HEAVY PHOTON MODULE G&S REFERENCING

HEAVY PHOTON SUPPORT STRUCTURE G&S REFERENCING

NOTES FOR PAGE 2: MODULE MOUNTING BONDING

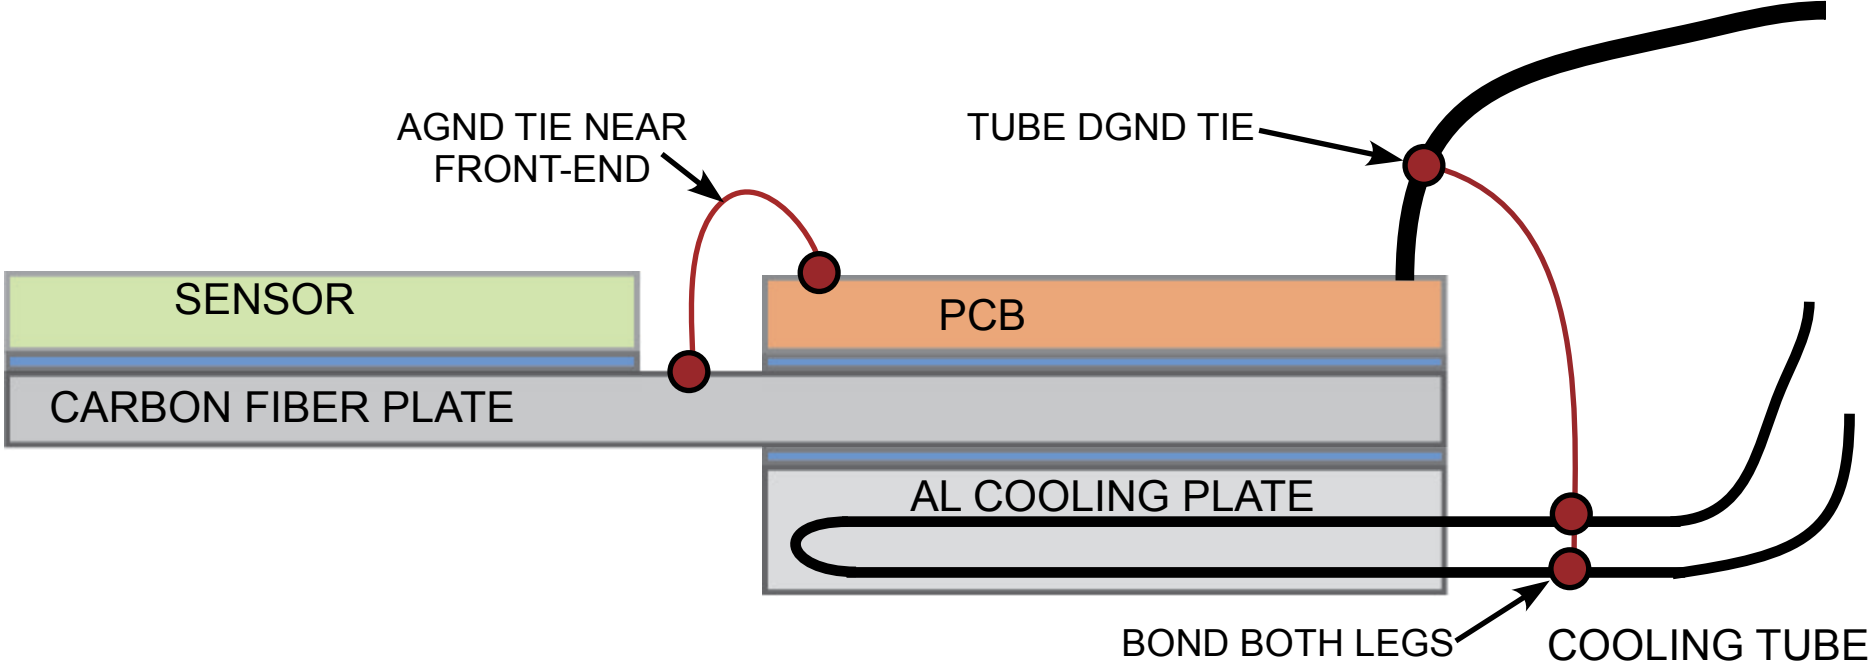
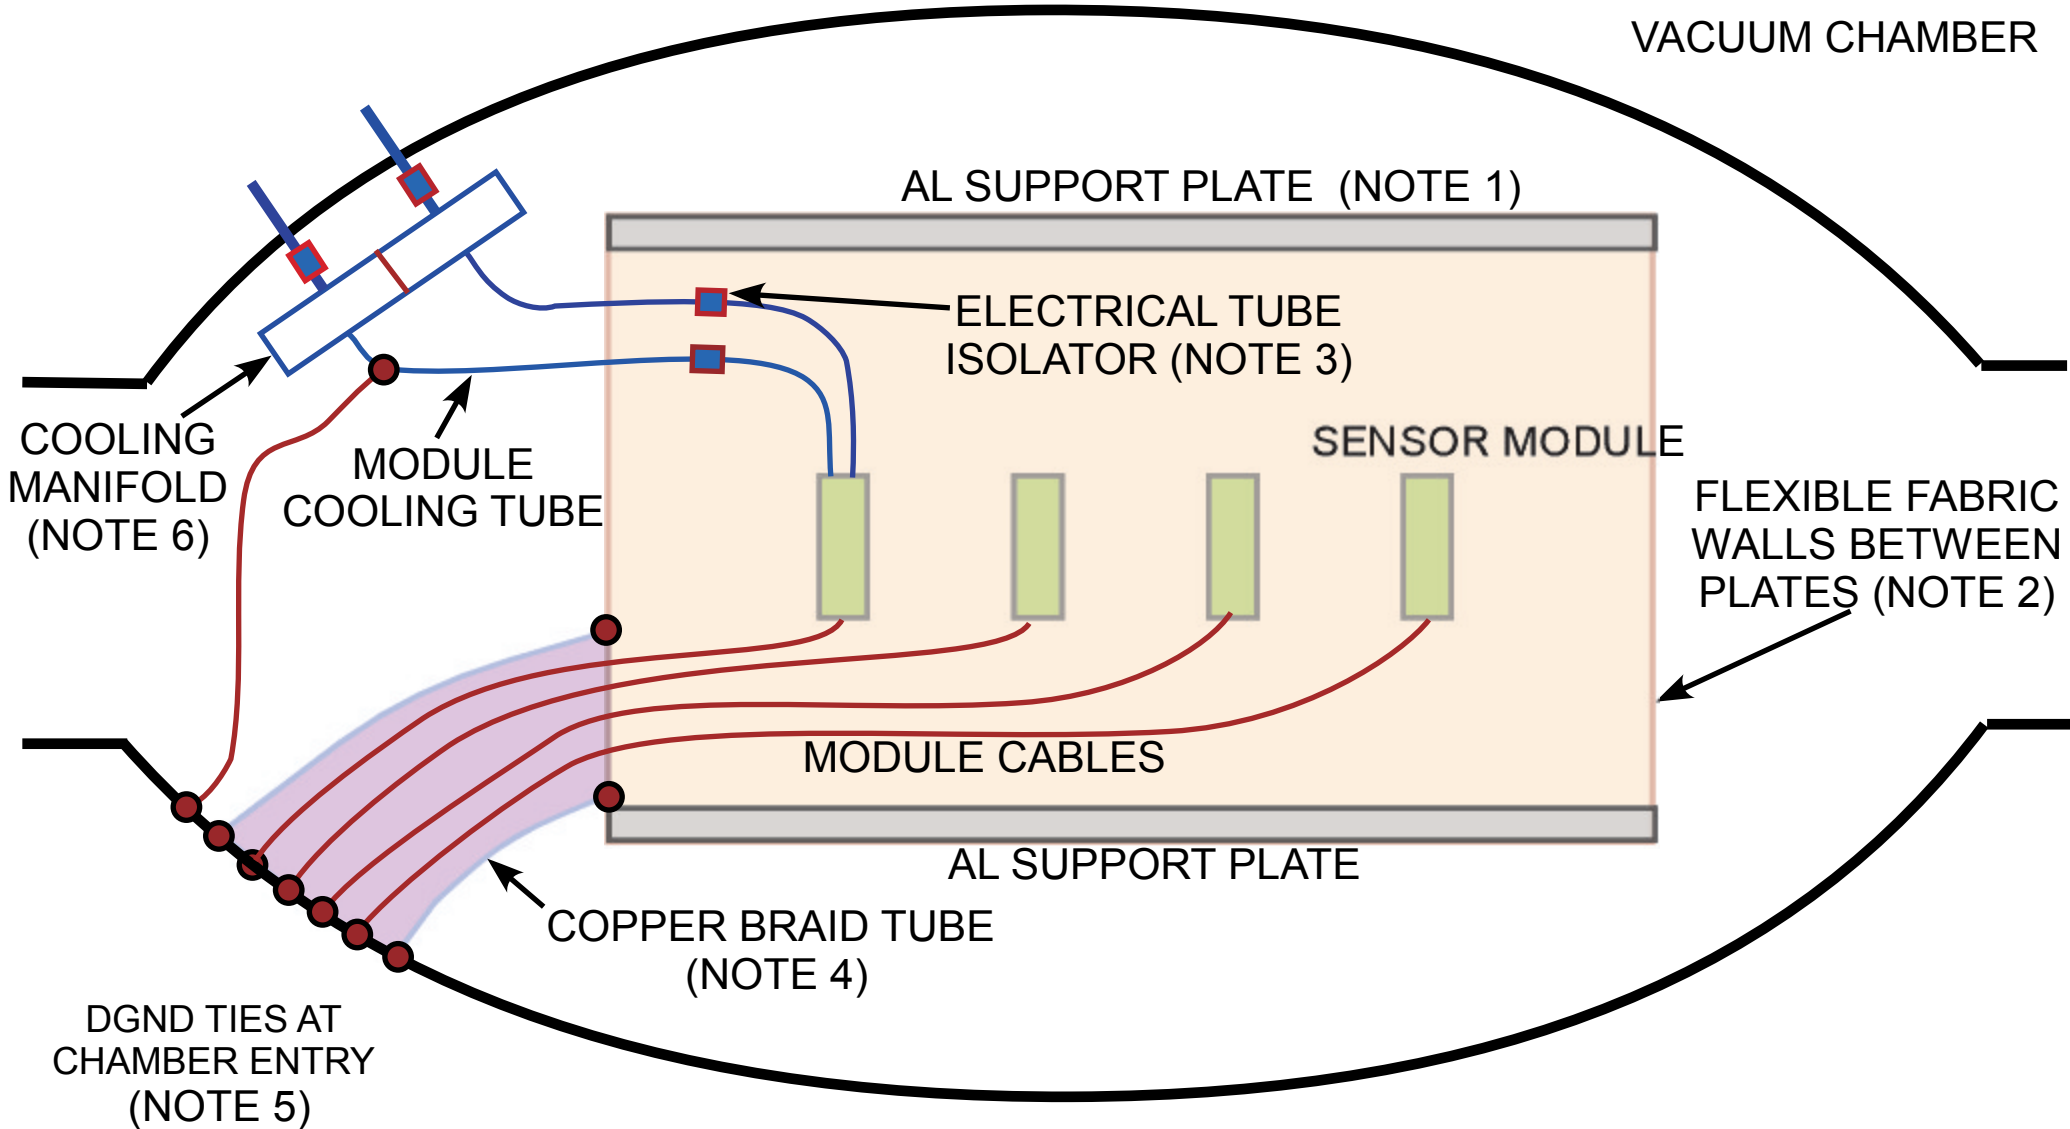
- (1) The two Al mounting plates should be isolated except for the electrical ties described here.
The modules should be isolated from their mounting plate.

- (2) Between the two plates a flexible shielding screen should be mounted.
The rear end of the mounting plate shield can have no screening to allow the deflected electron beam to continue without more scattering.
The flexible screen can be copper screening, Kapton/copper sheeting or nickel plated fabric.
The attachment to the mounting plate edges can be at ~20 mm centers.
The screening can have slots and modest openings as needed.

- (3) The two cooling tubes should have electrical isolators near the Al module cooling plate.
The cooling tubes should not electrically contact the mounting structure.

- (4) The electrical cabling from the vacuum chamber wall to the module connector should be grouped together.
A tin-plated copper tubular braid should be slipped over the whole group.
The braid should bond to the vacuum chamber wall at the cable entry area with multiple attachments or, better, circumferential capture.
The other end of the braid should attach to the mounting plate shield with circumferential capture or multiple tie points.

- (5) Module cable DGND is tied to vacuum chamber wall at entry point.
- (6) The cooling manifold is isolated from the vacuum chamber.
The resulting isolated tube array should have a bonding strap to the vacuum chamber near where the module cables and braid bond.
